**University of Northern Iowa**  
**RFP Q9345**  
**Addendum #1**  
**August 9, 2017**

**Vendor Questions**

Radio Test Points:

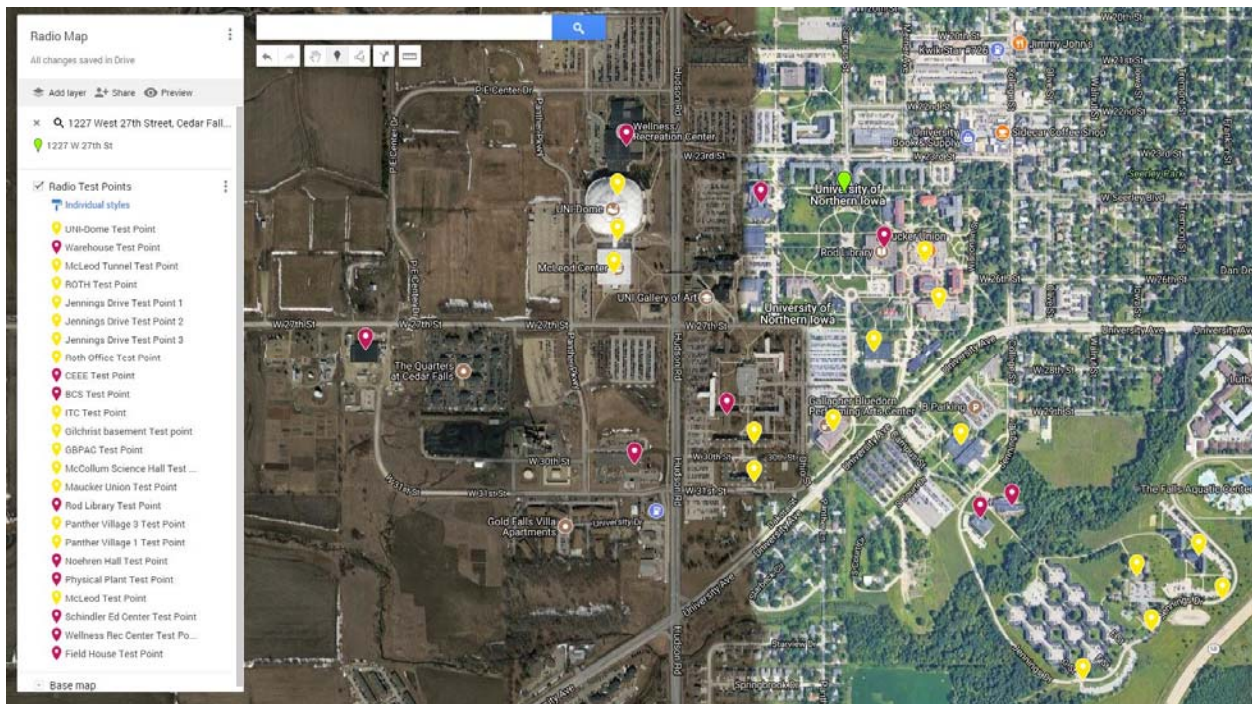
16. Page 7, 3.1.1 "Replace 800 MHz trunked radio system components (transmitters, combiners, antennas, repeaters, amplifiers, etc.) to increase signal strength to a level that allows in building and outside communications. Cover areas on campus where communication cannot be made or is poor (south campus near ROTH, inside GBPAC, some ground floors, etc.).

Is the awarded contractor to guarantee the coverage in the areas listed?

If so what are all the ground floors of what building need to be covered? Or is the RFP merely depicting the weak coverage areas as a statement knowing that replacing a nineteen (19) year old system will offer improvements? Please Clarify.

Will a DAQ (Delivered Audio Quality) test be required to be conducted on-site AFTER the new Infrastructure is installed?

- Yes, see included map. Post install we will do human testing with the dispatch center to ensure that communications are sufficient.

- See attached map.

- Yes. A score of 3.4 or above is required at test points (see map)
- Scoring
  - 1 - Unusable. Speech present but not understandable.
  - 2 - Speech understandable with considerable effort. Requires frequent repetition due to noise or distortion.
  - 3 - Speech understandable with slight effort. Requires occasional repetition due to noise or distortion.
  - 3.4 Speech understandable without repetition. Some noise or distortion present.
  - 4. Speech easily understandable. Little noise or distortion.
  - 4.5 Speech easily understandable. Rare noise or distortion.
  - 5. Perfect. No distortion or noise discernible.
